## 7. Draft EIS Section 4 Project Description

### 7.1 Section 4.1 Project Overview

■ **Figure 11 Modelled PW Discharge Location**

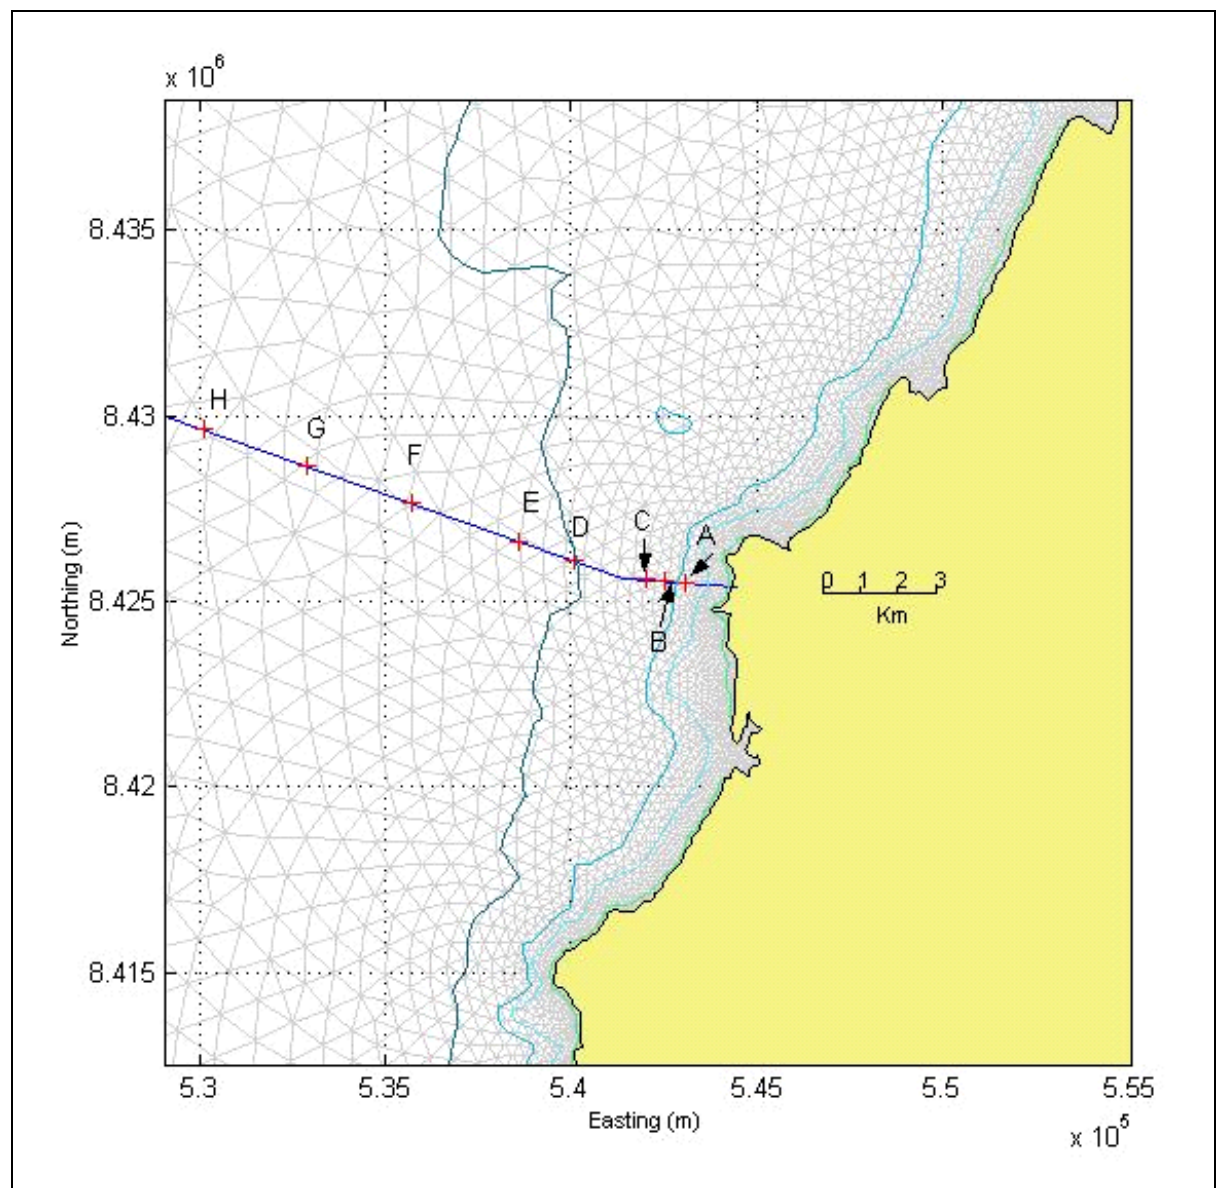
**NTG 76:** Please provide further justification for the stated hydrotest discharge location. See discussion Section 4.6.3 of this review.

***NTG 76: Please provide further justification for the stated hydrotest discharge location.***

**Discharge Location:** The modelling assessed eight discharge locations in addition to the preferred option presented in the Draft EIS (**Figure 11**). This study, along with the information presented above, indicates that the preferred location provides sufficient dilution to reduce contaminant concentrations to below levels that could potentially cause harm to the marine environment. The study indicated that it was necessary to locate the outfall outside the nearshore gyre which may recirculate the PW into the bay. Both Locations B and C were found to be outside this gyre; however, for added safety the discharge location was moved further offshore to a similar distance offshore to the export mooring.
